# OROVILLE COMPREHENSIVE NEEDS ASSESSMENT

## Independent Review Board Report

SUBJECT: Report No. 7

**Figure 1. Summary of Estimated Risks for CNA Potential Failure Modes (Existing Conditions)**

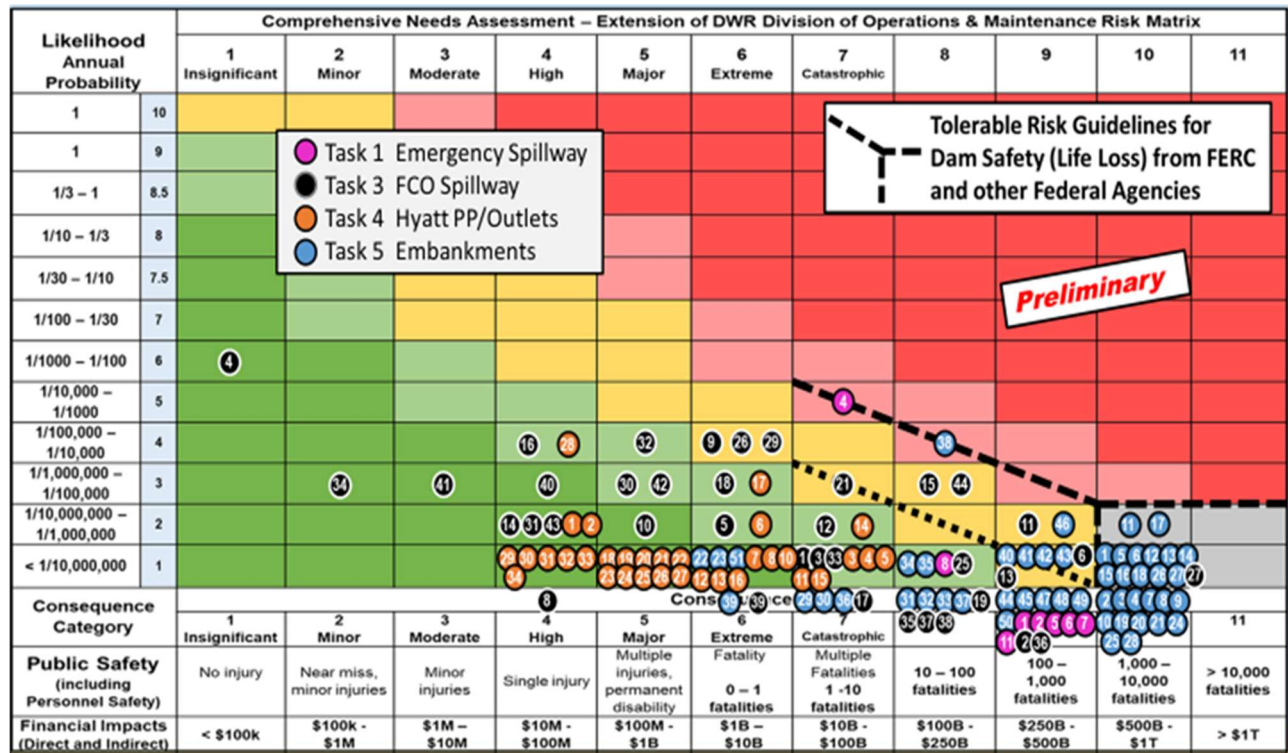
The IRB notes that the current risk estimates determined for the Oroville Dam complex are low, with the two highest risk PFMs identified as being on the threshold of commonly accepted tolerable risk.

The IRB notes that binning of the PFM risk estimates in one cell of the risk matrix implies an uncertainty in the likelihood and consequence estimates of about one order of magnitude. However, the IRB understands that the original CNA Project Team estimates, like the L2RA Team estimates, often implied greater uncertainty for some PFMs. The IRB understands that uncertainty has been considered by the CNA Project Team developing risk reduction measures for PFMs binned within at least two orders of magnitude of the threshold, which would normally be deemed as not warranting additional risk reduction. The IRB believes it is important to explicitly acknowledge the inherent uncertainty in the risk estimates and **the IRB recommends** that the CNA Project Team discuss the issue of uncertainty in the likelihood and consequence estimates in the CNA Project Report and consider the need to portray uncertainty in graphical representations of the estimates.

The IRB found that the risk graphics developed to illustrate the existing condition risk matrix and the risk reduction outcomes of implementing various plans were very effective. As a means of further enhancing these figures, the IRB suggests that the CNA Project Team explore the possibility of using vectors on the matrix, or other graphical means, to indicate the reduction of risk achieved by plans.

| M7-1 | The IRB recommends that the CNA Project Team discuss the issue of uncertainty in the likelihood and consequence estimates in the CNA Project Report and consider the need to portray uncertainty in graphical representations of the estimates. |
